## POWERLINK QUEENSLAND REVISED REVENUE PROPOSAL

Nuttall Consulting - Review of AER Draft Decision

**Review of AER draft decision  
Repex modelling advice**

**9 November 2016**

**Figure 1 Proportion of replaced assets – circuit breakers**

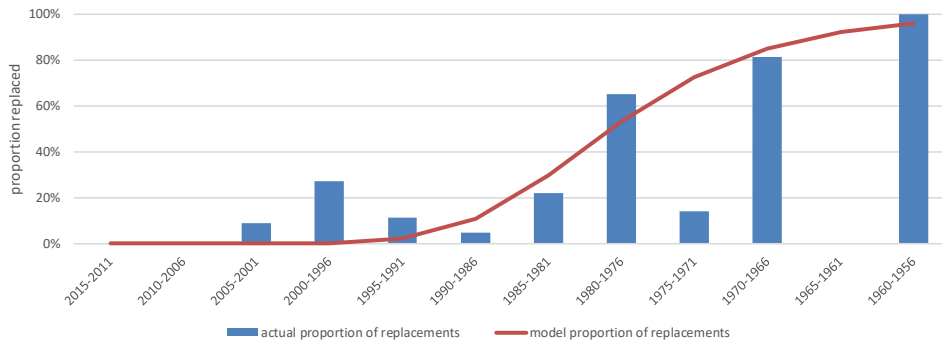
The figures show that the model provides a reasonable match to the actual replacements over the calibration period. These graphs *do* indicate that there is an increased number of young replacements than assumed by the model, most notably for circuit breakers and voltage transformers. However, if it is assumed that these replacements are valid and reflect a replacement process that is consistent through the calibration and forecast period, it suggests there may be some underlying dynamic that is not captured by the model. For example, a cohort of assets within the population that has a younger life and so could be modelled as a separate category.

Importantly, my indicative investigations through the model suggest that this model inaccuracy may be biased against Powerlink and not in its favour<sup>17</sup>. That is, this inconsistency is not shortening the overall population life; it is slightly increasing it.

**Figure 6 Secondary system proportion of replacements**

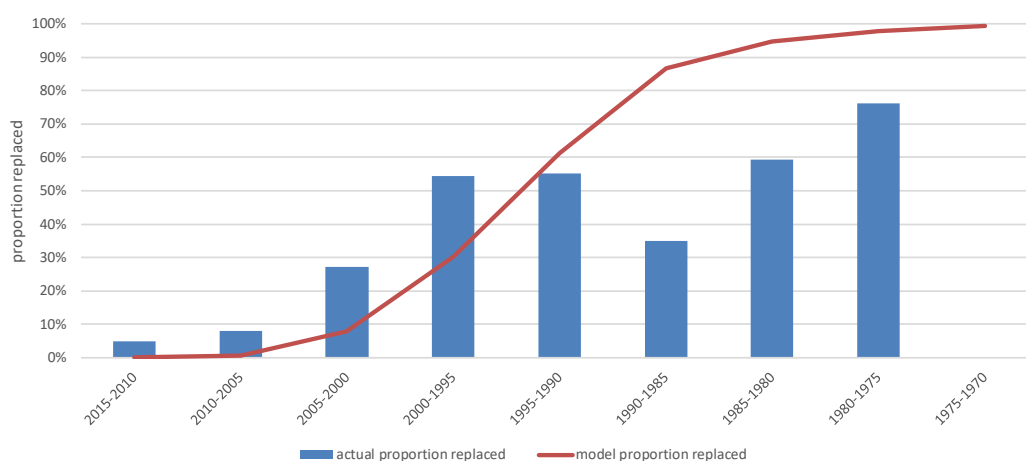
Figure 6 indicates that there is a modest inconsistency between the model and the actual replacement, where the spread of the age is wider than suggested by the model. This shape suggests that the model may not be capturing the replacement dynamics accurately. As discussed in my previous report, it suggests there could be two replacement mechanisms, one reflecting an asset technology with a short life and another one with a longer life<sup>21</sup>. As I also discussed in the original report, this often occurs when modelling secondary systems because the different technologies that have evolved over time have differing lives (i.e. the move from electro-mechanical relays to electronic, and then to microprocessor).

I have repeated the indicative analysis I applied in my previous report to investigate this matter<sup>22</sup>. In this analysis I have split the age profile into two and calibrated two separate lives: one reflecting a notional shorter age technology and one reflecting a notional longer age technology. Importantly, this revised analysis has found a similar result to that discussed in my original report: this model inaccuracy may result in a small bias against Powerlink rather than in its favour. That is, this simplification is causing a slightly longer aggregate life for the overall population rather than a shorter life.
